Addendum No. 001

3 Courthouse Roofs Replacement
Clarksville, TN

Issue Date: 3/11/2025

Walter P Moore
1201 Peachtree Street NE, Suite 1600
Atlanta, GA 30361

AERIAL IMAGE OF COURTS COMPLEX

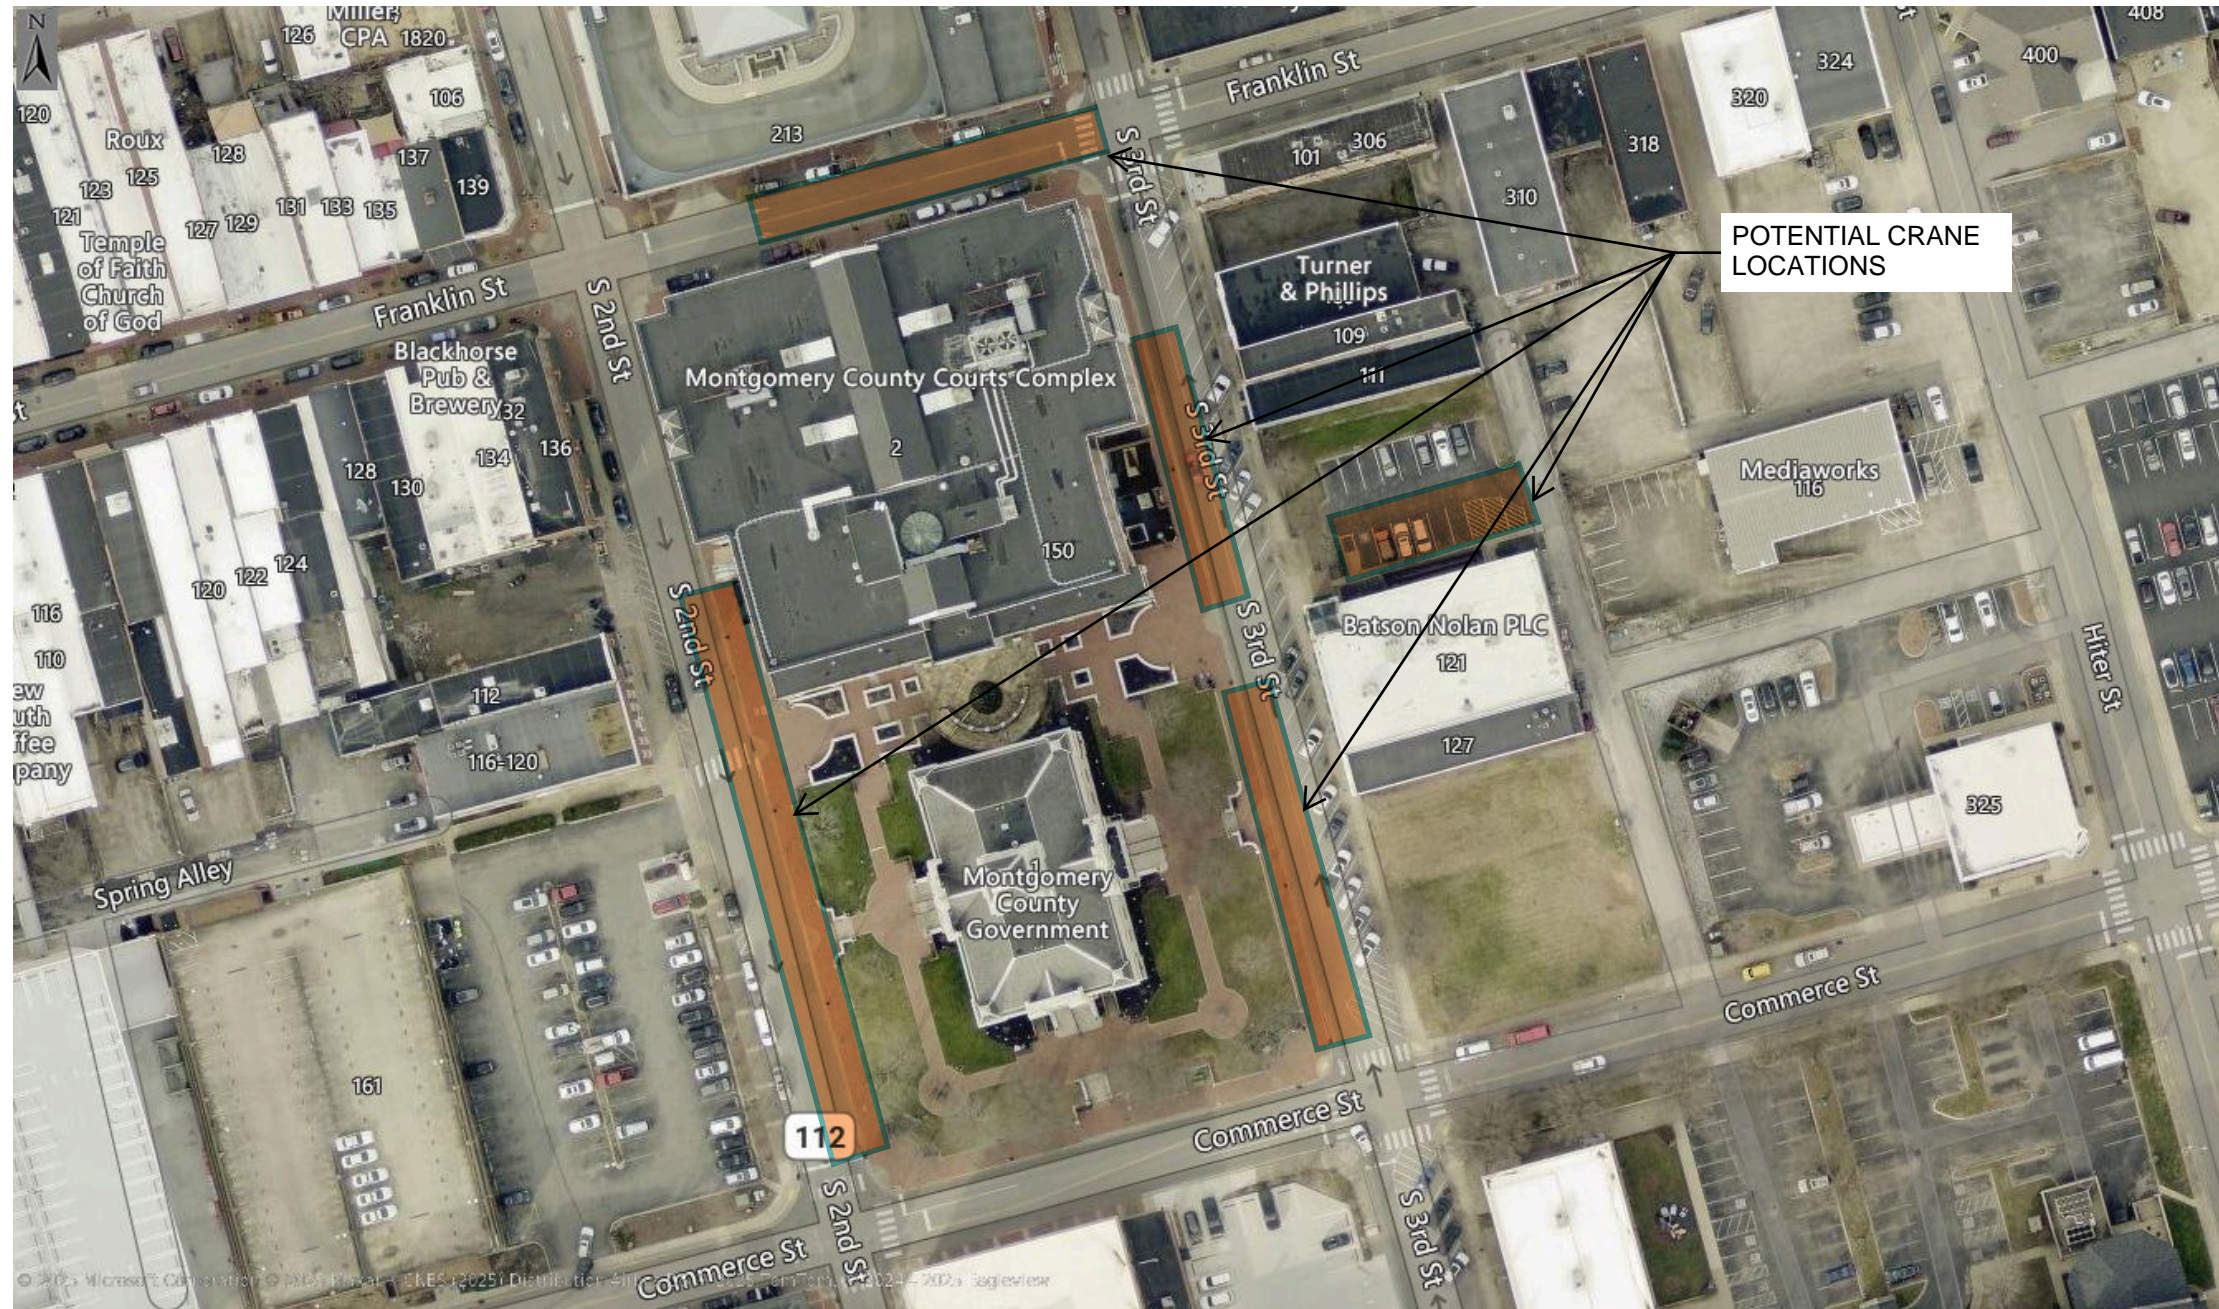
- See attached spreadsheet with responses to bidders' Requests for Information submitted as of 3/11/25, including attached aerial image for potential crane locations.

#	Date of Request	Request for Information	Date of Response	Response
1	3/3/2025	No site plan is provided in the plan documents. Where will the contractor be permitted to stage work for each building in proximity to each building?	3/11/2025	County and/or WPM will provide a site plan showing possible areas for staging. Vacant lots may be leased if property owners will allow such a lease. This is up to the bidding contractor to make contact with property owners prior to the bid date. Parking spaces may be purchased from the City of Clarksville parking authority. Montgomery County only owns the parking lot adjacent to the Courts Annex building. Two spaces can be provided near the entry point of this parking lot for equipment staging of that building. Contractors may park at the County owned lot located at the corner of 2nd and Union street at no cost. Any other downtown parking lot or garage can be utilized if approved by that parking lot's owner for payment or possibly for free depending upon the lot and the owner. A crane setup location map will be provided for possible options. It will be the contractor's responsibility to schedule and abide by the City of Clarksville Street Department's closer or detour guidelines for any street impacts or lane closures. The Parking Authority will need to be contacted for parking impacts for the crane.

2	3/3/2025	Where will dumpsters for roof removal/demo operations be permitted to be staged for each building location?	3/11/2025	County and/or WPM will provide a site plan showing possible areas for staging. Any onstreet parking can be purchased from the City Parking Authority to store dumpsters pads. Existing asphalt pavement must be protected from damages by means of plywood or 2x sacrificial material before the dumpster is placed. Damages will be the contractors' responsibility to repair. It is not the County's intention to specify the exact location that the contractor can purchase for a dumpster. Contractor may decide and include the proper fee for reserving those number of parking spaces along 2nd, 3rd, or Franklin Streets.
3	3/3/2025	To establish OSHA compliant fall protection as well as protection for containment of falling object hazards, is the County expecting the Courthouse at 1 Millennium Plaza to be fully scaffolded at the eaves with a full platform deck and debris netting around the entire building with overhead pedestrian protection canopies at each entrance to ensure safe pedestrian access around the building and at entrances for egress and ingress?	3/11/2025	Scaffolding and OSHA compliance is up to the bidding contractor. Means and methods of accessing each roofing component is the sole responsibility of the contractor to establish and provide and is not dictated or limited to the contractor. With each contractor choosing their preferred means and methods of accessing each roof point, any damages to plants, yard, mulch, paver stones, concrete, building components will be the contractors responsibility to repair or replace to the Owner's preference to make it as good or better than the existing condition. Main entry doors to each building must be protected from any possibility of falling debris.
